**Addendum
No. 2**

Date: January 23, 2019

Project: CRSD Charlton School Renovations Phase 2B
Secured Entry & HVAC Renovations
SRS-18005-ChRen2 B

TYPICAL 2-WAY VALVE COIL CONNECTION

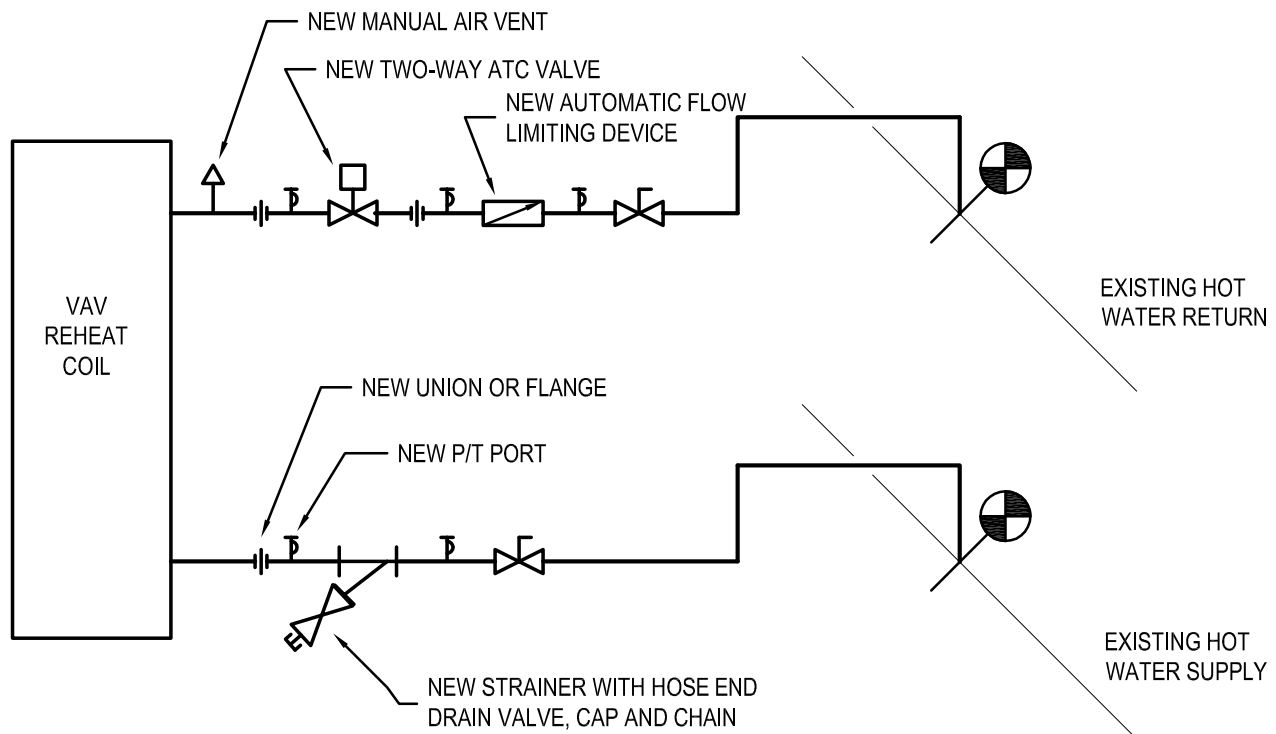
3. **Question:** Alternate 2 is to replace the VAV's, there is not VAV spec or installation detail. Please provide.
Answer: VAV typical removal and new work is shown in details 2/M8.5 and 2/M8.11. For additional information see sketch SK-M.1 – TYPICAL 2-WAY VALVE COIL CONNECTION, attached. See specification section 23 36 11 – AIR TERMINAL UNITS, attached.

Answer: See revised Bid Form, attached.
6. **Question:** With the alternate to replace the VAV Units, will the valves / hook-ups for each VAV unit be replaced as well? There is not details showing this.

Answer: VAV typical removal and new work is shown in details 2/M8.5 and 2/M8.11. For additional information see sketch SK-M.1 – TYPICAL 2-WAY VALVE COIL CONNECTION, attached.

1. PROVIDE AUTOMATIC FLOW LIMITING DEVICE PER UNIT FLOW REQUIREMENTS AS SHOWN IN EQUIPMENT SCHEDULES.
2. THIS ARRANGEMENT IS TYPICAL FOR BOTH HOT WATER COILS AND CHILLED WATER COILS. BOTH COIL CONNECTIONS ARE REQUIRED FOR ALL UNITS UNLESS NOTED.
3. PROVIDE COIL CONNECTIONS DESCRIBED ABOVE ALL UNITS EXCLUDING AIR HANDLING UNITS AND ROOF TOP AIR HANDLING UNITS.
